HISTORIC AND DESIGN REVIEW COMMISSION

HDRC CASE NO: 2024-375
ADDRESS: 1002 KAMPMANN BLVD
LEGAL DESCRIPTION: NCB 7011 BLK LOT 9 & W 48 FT OF 8
ZONING: RM-4, H
CITY COUNCIL DIST.: 7
DISTRICT: Monticello Park Historic District
APPLICANT: Adan Ochoa/AO Design, LLC
OWNER: RYAN NATASHA
TYPE OF WORK: Demolition of a rear accessory structure, construction of a 2-story, rear accessory structure
APPLICATION RECEIVED: November 01, 2024 (December 1, 2024, 30-day Demolition Hold)
60-DAY REVIEW: December 31, 2024
CASE MANAGER: Edward Hall

REQUEST:

OVERALL FLOOR PLAN

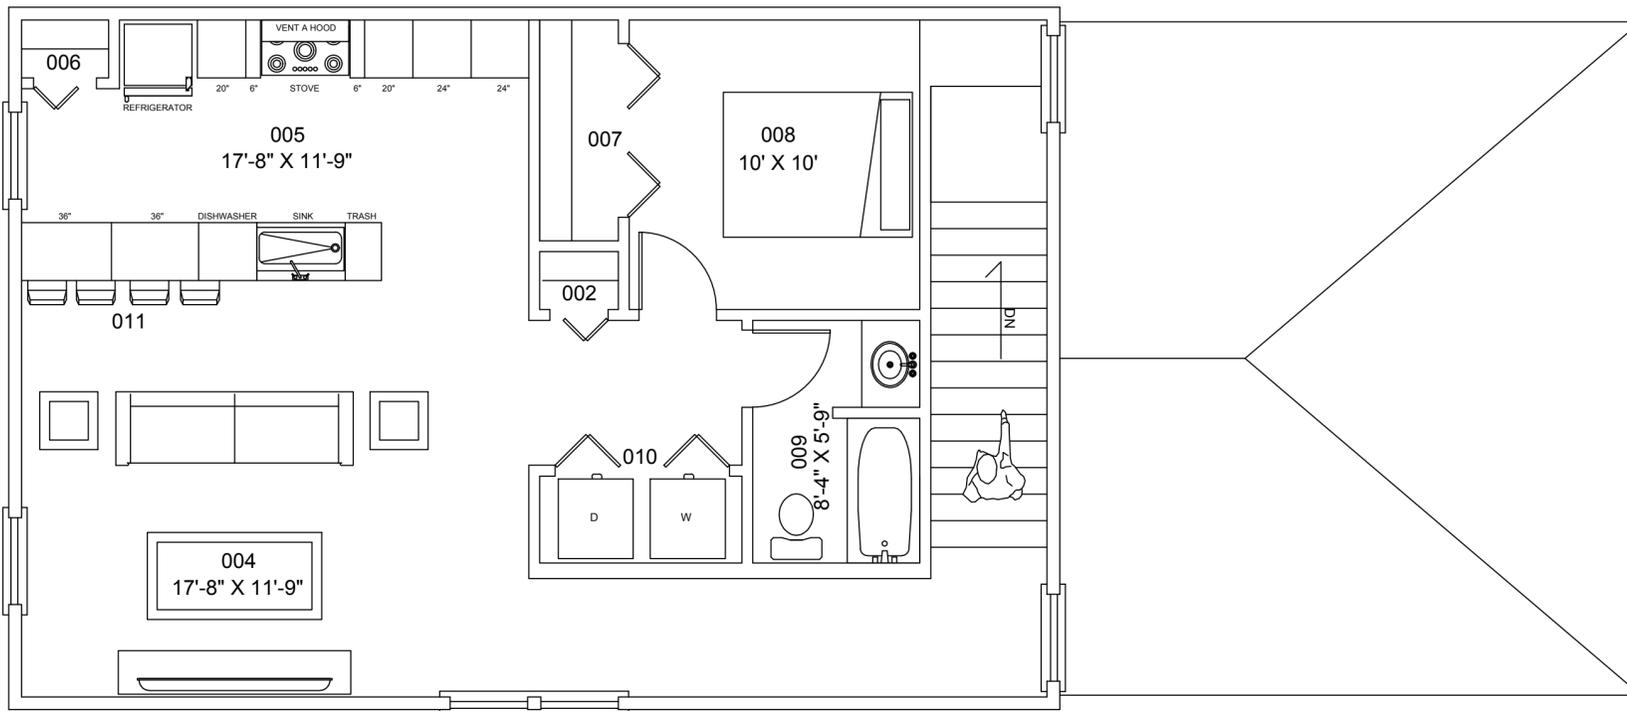
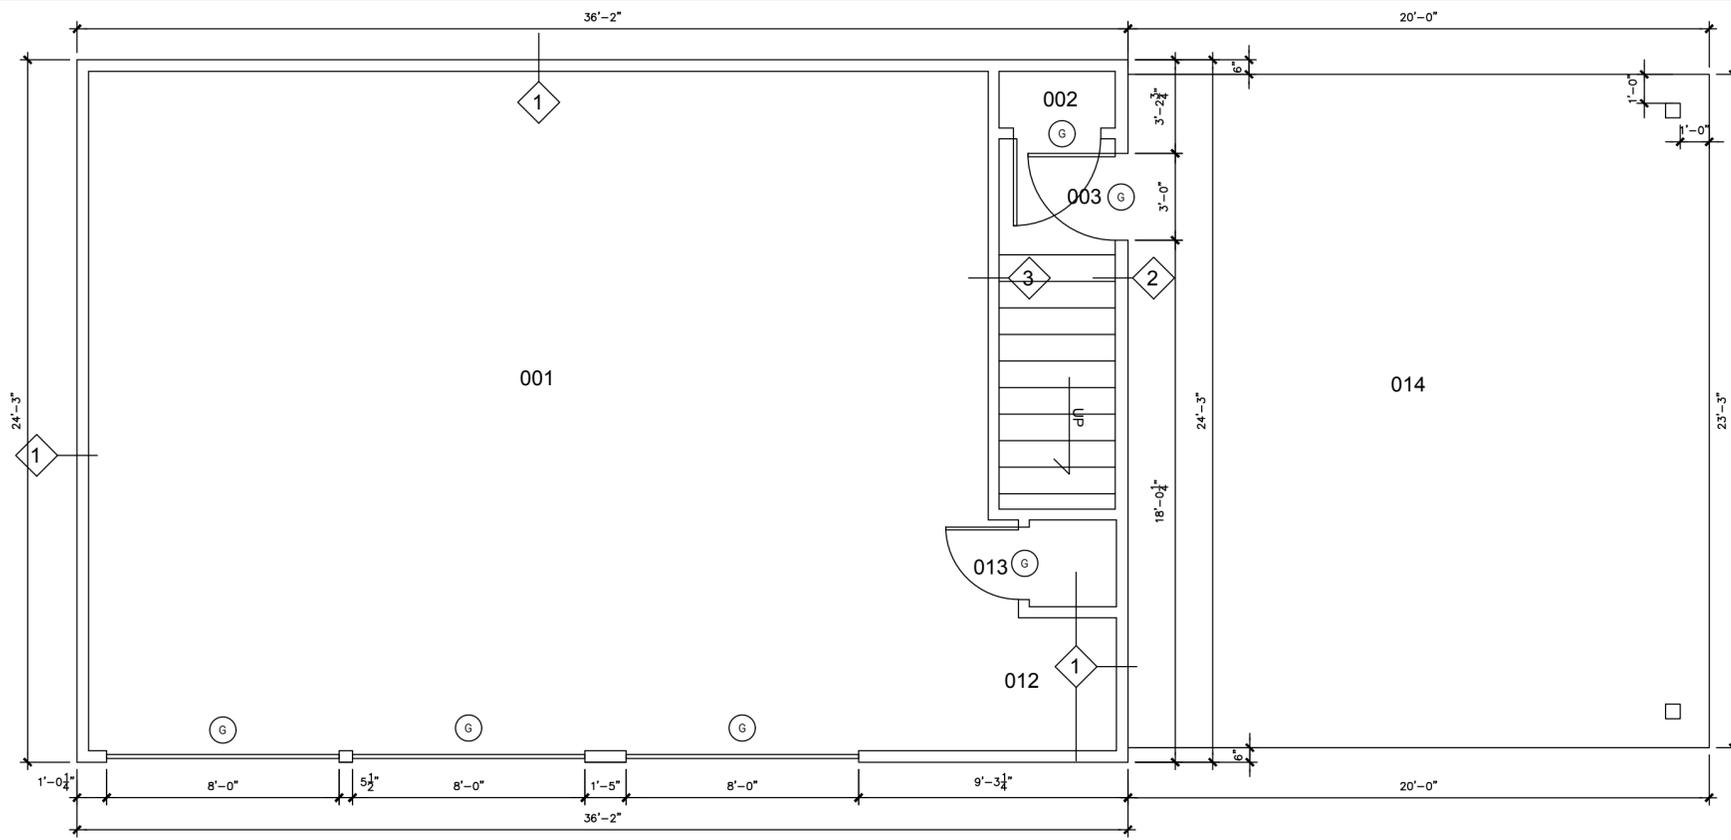
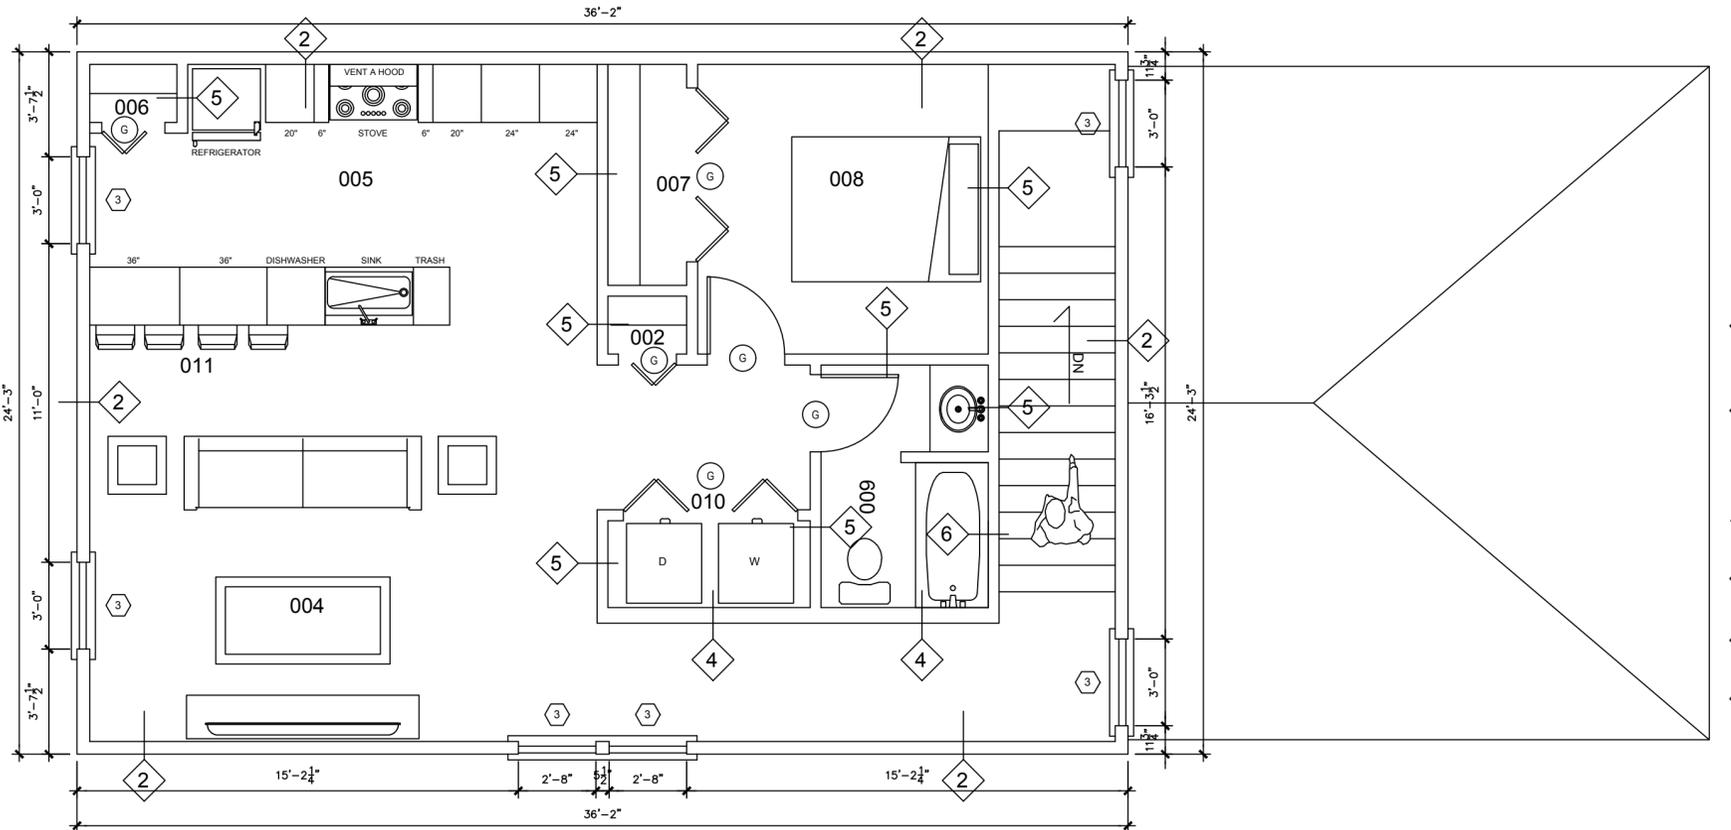
- g. SCALE & MASS (Rear Accessory Structure) – The applicant has proposed to construct a new, 2-story, rear accessory structure to feature a footprint of approximately 1,360 square feet and an overall height of approximately twenty-three (23) feet. The Guidelines for New Construction 5.A. notes that rear accessory structures are to feature a massing and form that is visually subordinate that that of the primary historic structure in regards to their height, massing and form, should be no larger in plan than forty (40) percent of the primary historic structure’s footprint and should relate to the period of construction of the primary historic structure. The historic structure, per BCAD, features a footprint of approximately 1,870 square feet. The proposed new construction’s footprint exceeds the recommended forty (40) percent of the primary structure’s footprint. As proposed, the new construction is not consistent with the Guidelines. Staff recommends both the height and footprint of the proposed accessory structure be reduced.

- i. That the applicant reduce the proposed footprint to be consistent with the Guidelines, as noted in finding g. The proposed footprint should not exceed forty (40) percent of the historic structure’s footprint.

1 NORTH ELEVATION
 Scale: 1/4" = 1'-0"

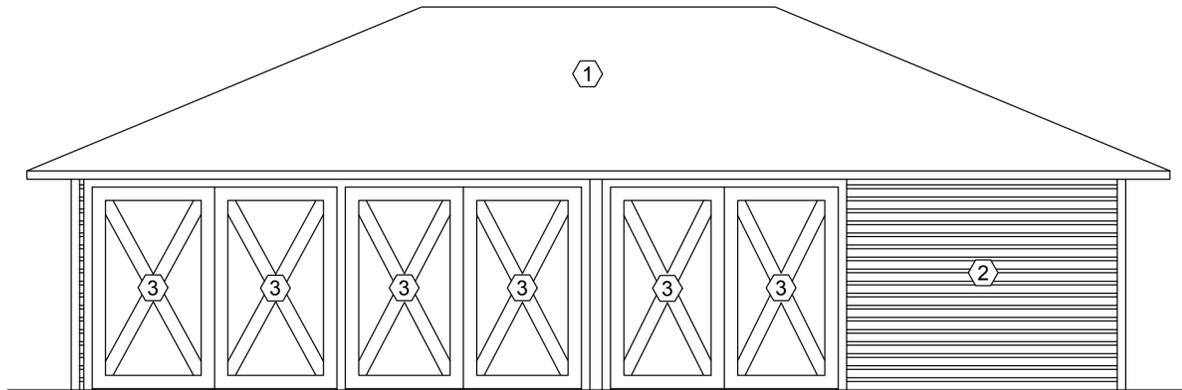
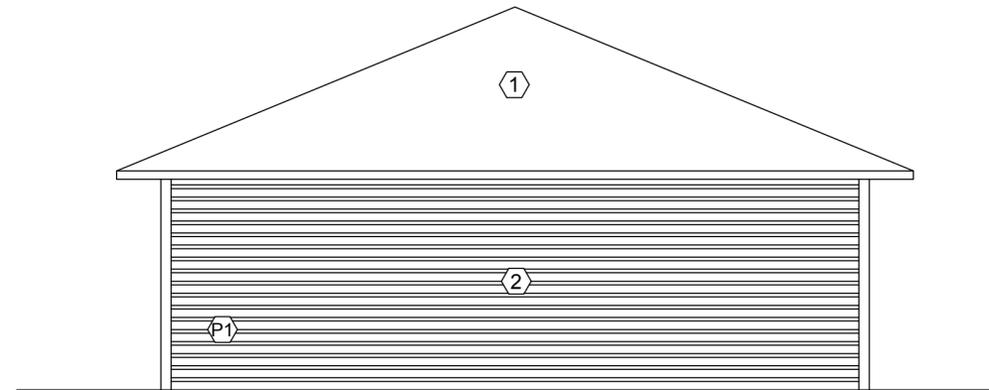
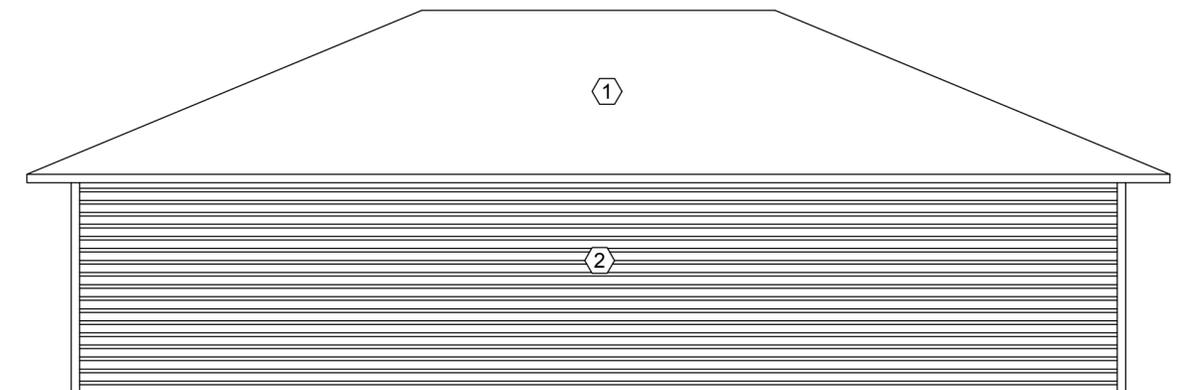
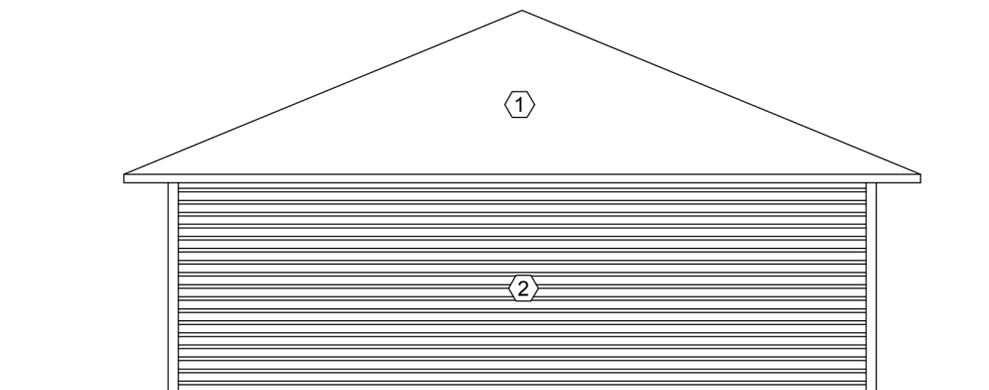
- k. CHARACTER / ARCHITECTURAL DETAILS (Rear Accessory Structure) – The applicant has proposed new construction that features large portions of facades that feature no or little articulation and separation. Additionally, the applicant has proposed a roof form that features a large, hipped roof. The primary historic structure on site features façade articulation and fenestration throughout each façade, and roof forms that are divided between the structure’s massing. Staff finds that the proposed new construction should feature additional fenestration, façade articulation, and a modified roof form to further relate it to the primary historic structure on site. Additionally, each of the previously recommended revisions could contribute to the reduction in perceived massing.

- ii. That the applicant reduce the structure’s overall height as to appear as a subordinate structure on site.
 - iii. That the applicant introduce additional fenestration to each façade as well as additional façade articulation. Additionally, staff recommends the applicant revise the structure’s roof form to relate to the roof form of the primary historic structure on site and to reduce the proposed structure’s massing.
